Addendum #: Addendum #4
Issue Date: 04/08/2024

The following additions, clarifications and revisions have been made to the Contract Documents:

Job #: 8-22-01-011 Edgar County Jail
 TBD SPRINGFIELD RD
 PARIS, Illinois 61944

LIGHTING MEZZANINE PLAN
 - JAIL

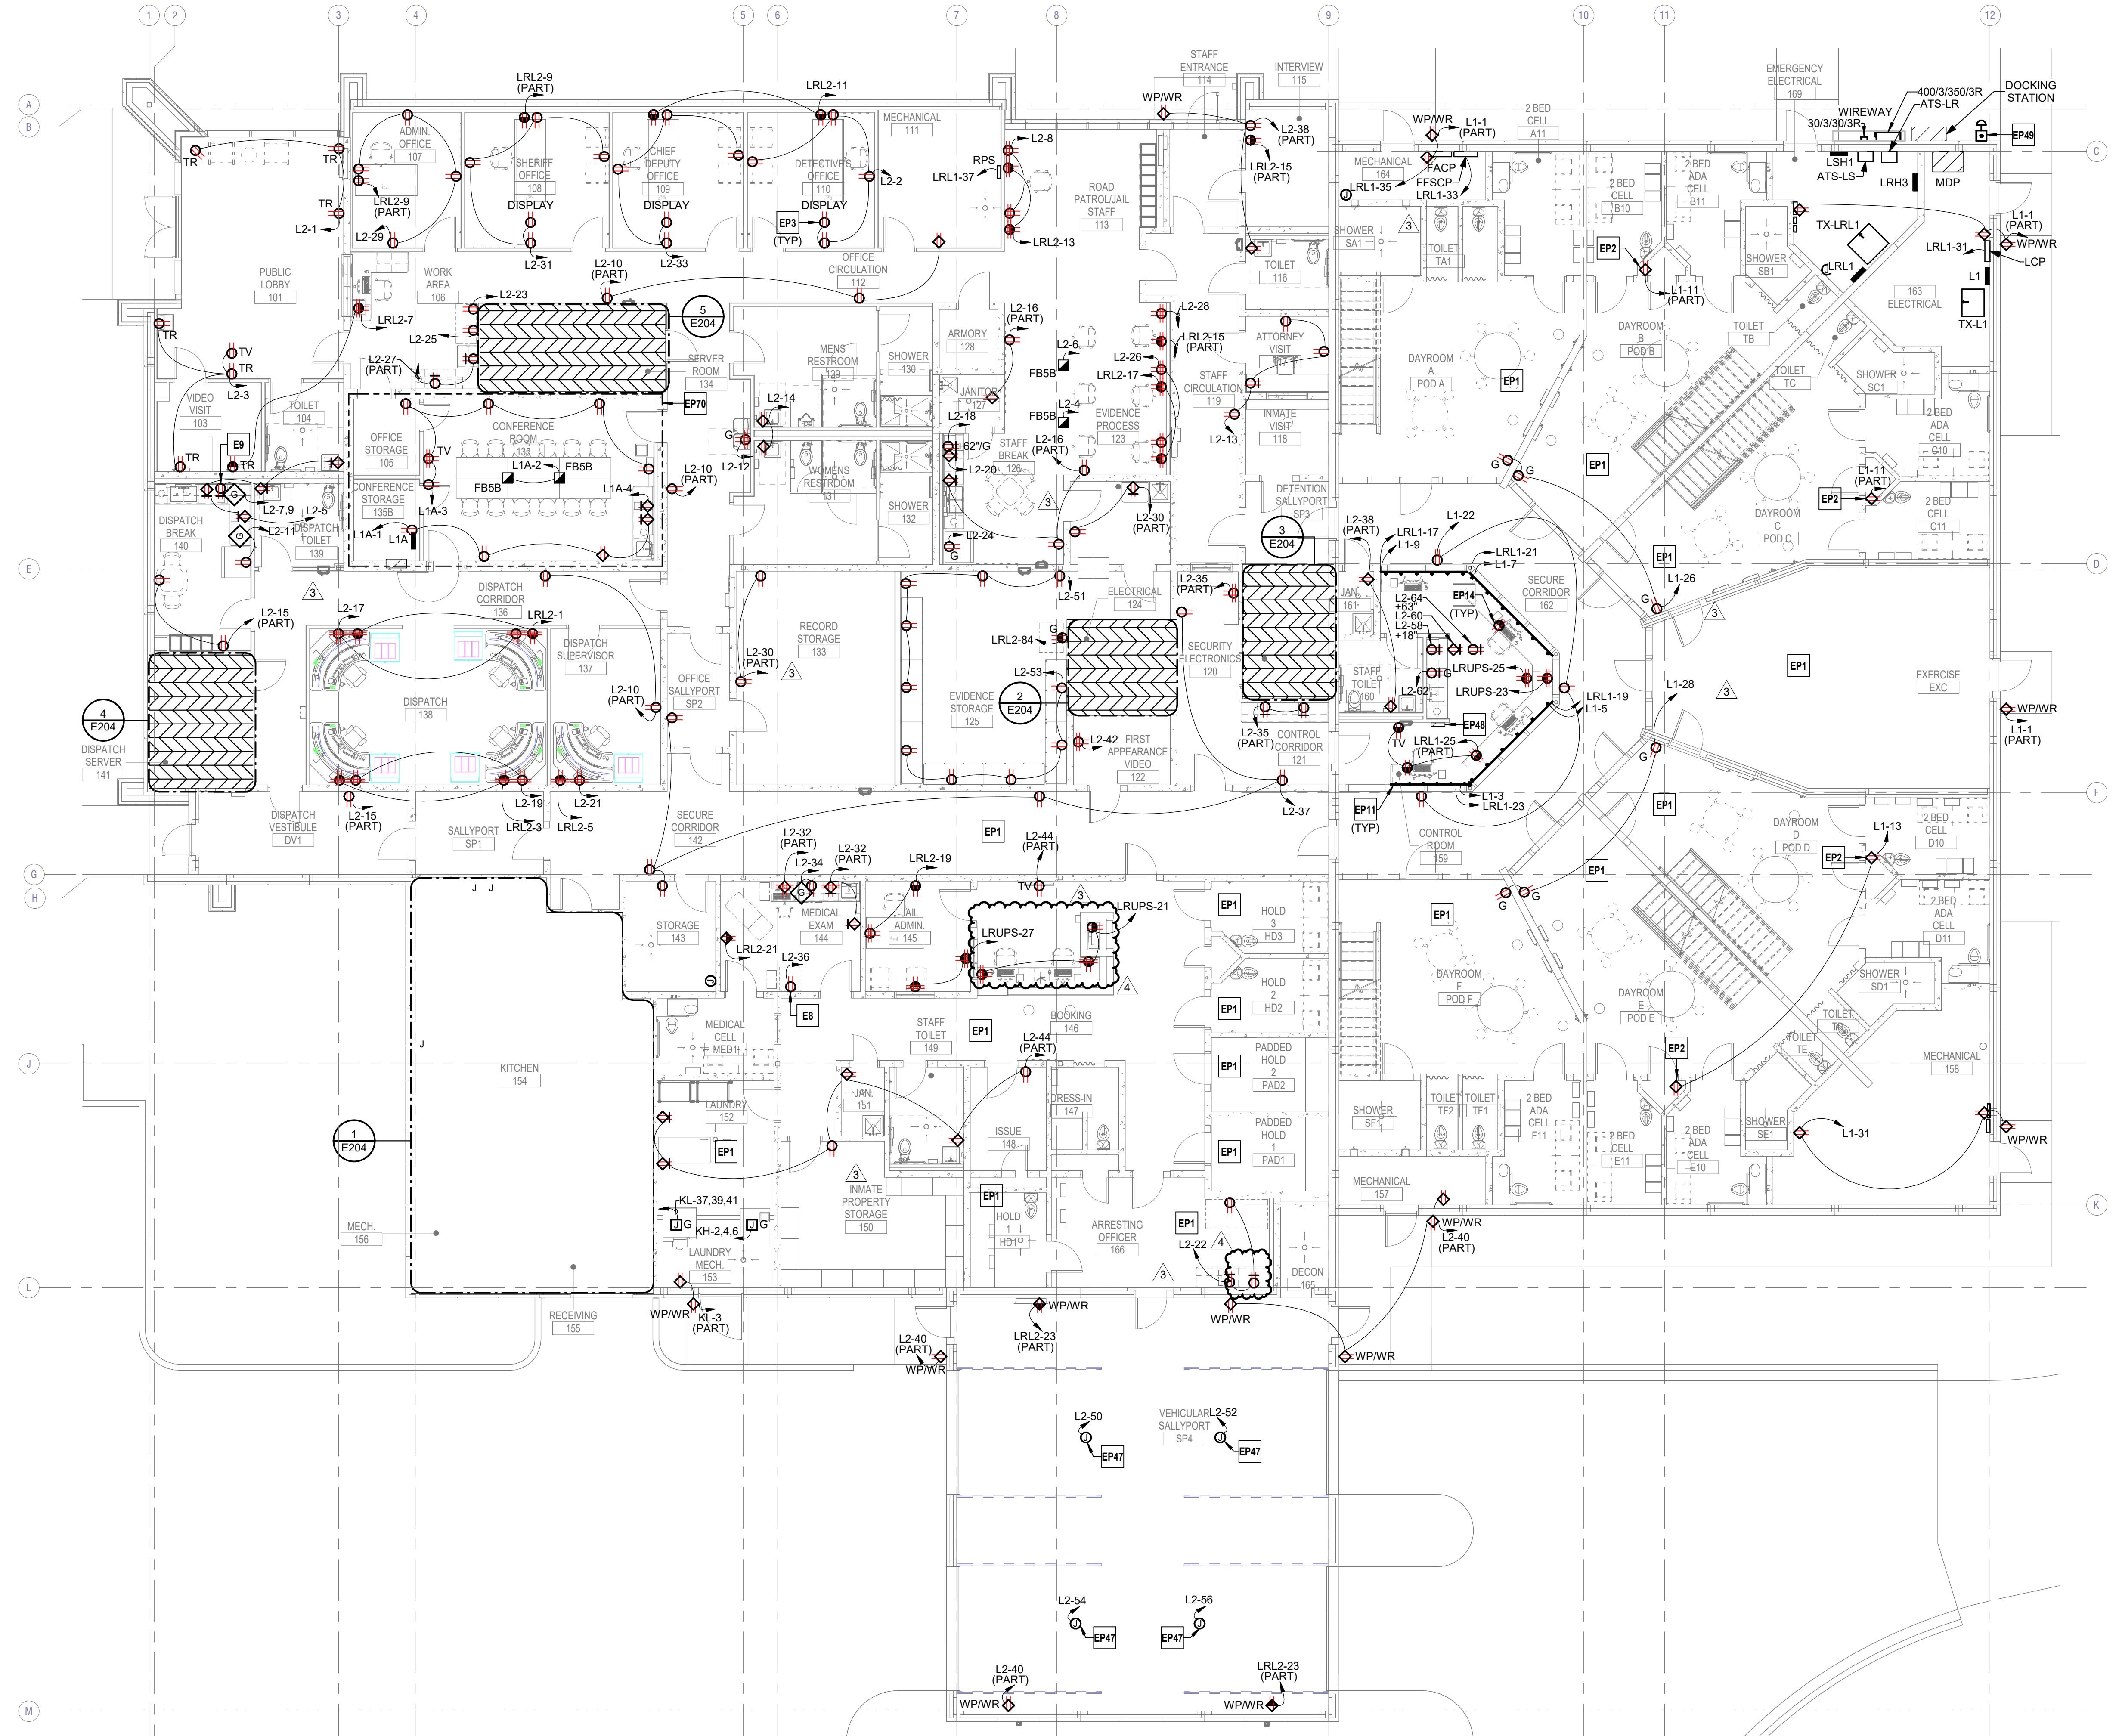
- 1. SHEET E100 – ELECTRICAL SITE PLAN
 - A. ADD type U2 for sign back light.
- 2. SHEET E102 - LIGHTING MEZZANINE PLAN – JAIL
 - B. Relocated and added exterior lights.
 - C. ADD type U2 Undercabinet lights in select locations.
- 3. SHEET E201 – POWER FIRST FLOOR PLAN - OVERALL
 - A. REVISE Various receptacle locations.
- 4. SHEET E301 – EQUIPMENT CONNECTION FIRST FLOOR PLAN - OVERALL
 - A. Updated plumbing valve power locations.
- 5. SHEET E400 – LIGHT FIXTURE SCHEDULE
 - A. ADD Type U2 light fixture.

1 HVAC FIRST FLOOR PLAN - AREA B
 1/4" = 1'-0"

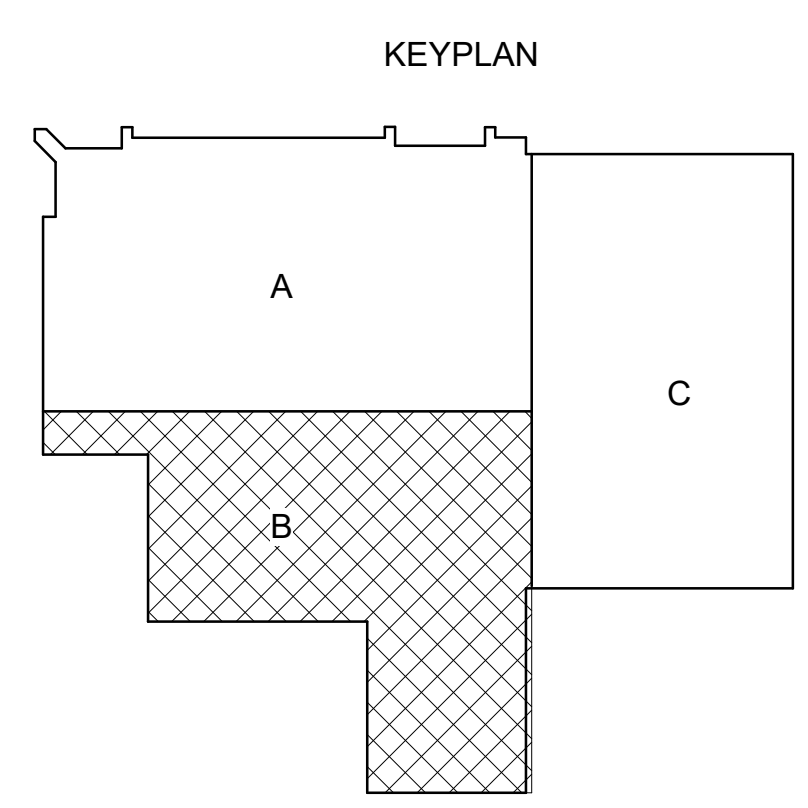
- 1. SHEET M101.A – HVAC FIRST FLOOR PLAN – AREA A
 - A. Revised duct routing in Conference Room 135.
 - B. Added section views 2 and 3 to sheet M101.A.
- 2. SHEET M101.B – HVAC FIRST FLOOR PLAN – AREA B
 - A. Revised VAV 1-19 and VAV 1-21 duct routing to avoid precast panel joint clearances.
 - B. Revised location of 30" x 16" transfer boot to avoid precast panel joint clearances.
 - C. Added keynote M44 to drawings.
 - D. Revised location of L 1 to be centered on precast panel.
- 3. SHEET M101.C – HVAC FIRST FLOOR PLAN – AREA C
 - A. Revised VAV 1-19 and VAV 1-21 duct routing to avoid precast panel joint clearances.
 - B. Revised location of 30" x 16" transfer boot to avoid precast panel joint clearances.

- C. Added keynote M44 to drawings.

1 PLUMBING FOUNDATION PLAN
1/8" = 1'-0"

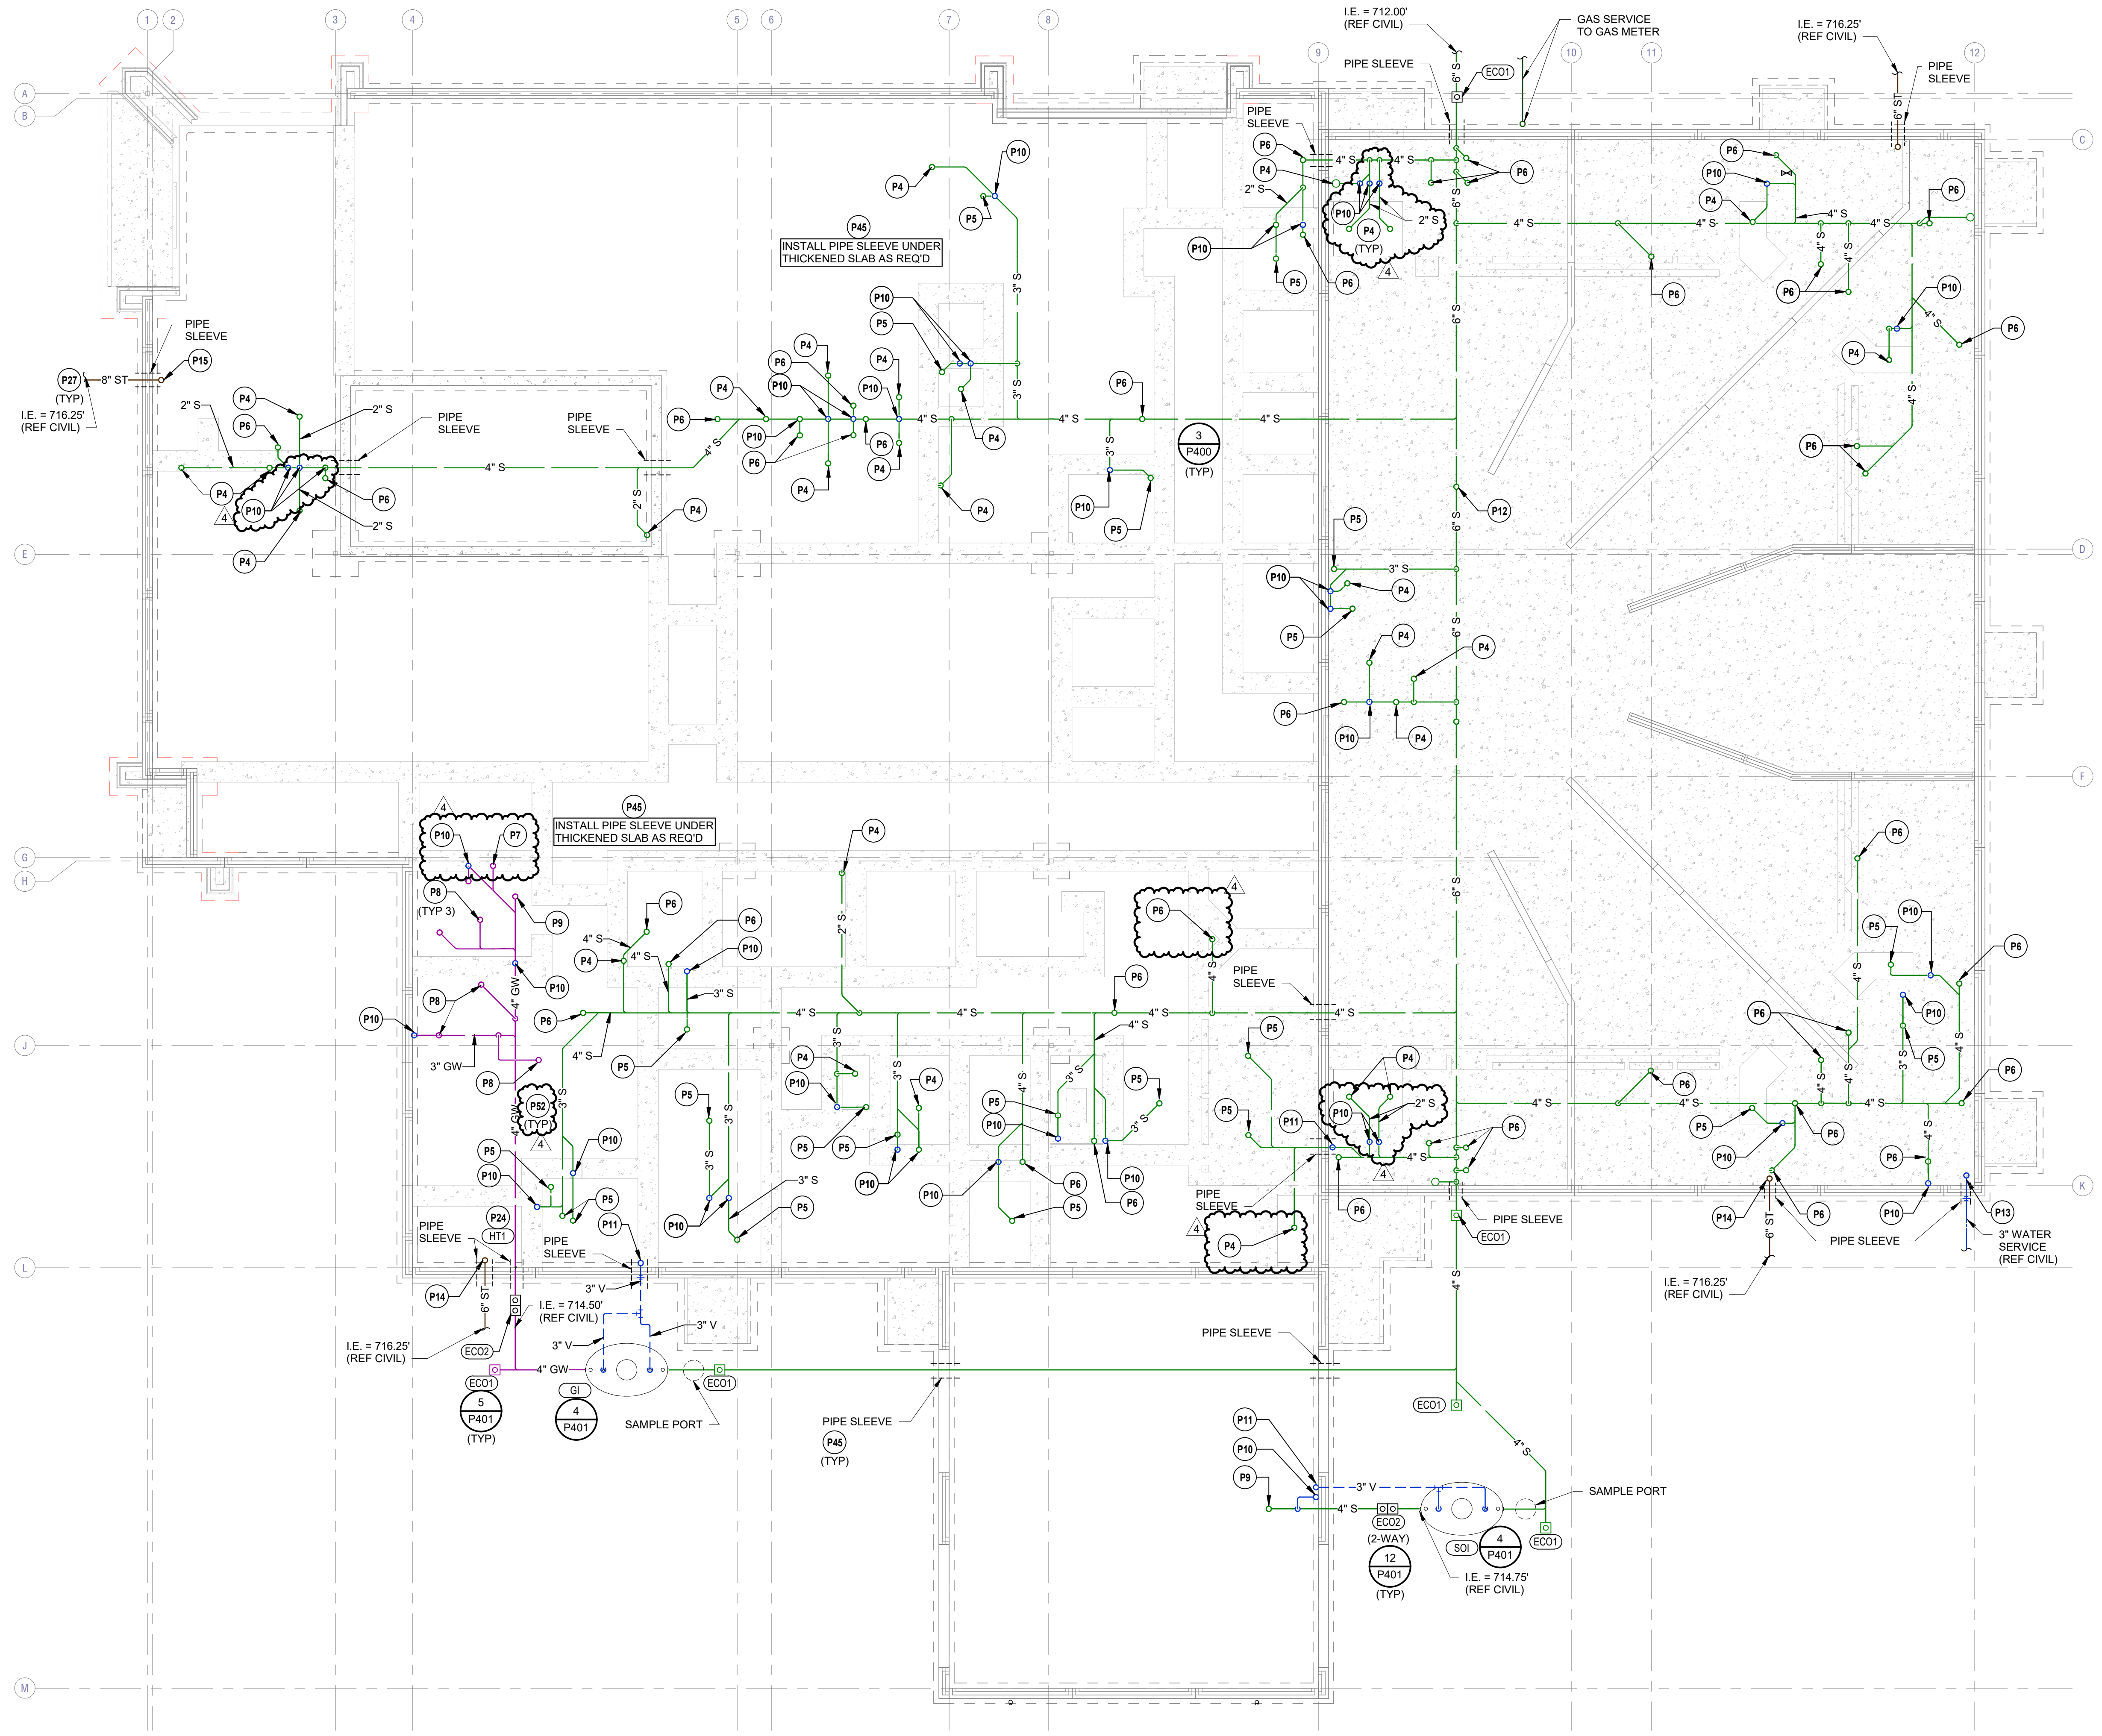
1. SHEET P100 – PLUMBING FOUNDATION PLAN
 - A. Revised kitchen piping.
 - B. Revised sanitary pipe serving Holding cells 2 & 3.
 - C. Added vent piping to restrooms.

- D. Revised shower drain and vent pipes serving Pod A & F showers.
 - E. Relocated floor drain pipe serving Decon 165.
2. SHEET P101 – PLUMBING WASTE & VENT FIRST FLOOR PLAN - OVERALL
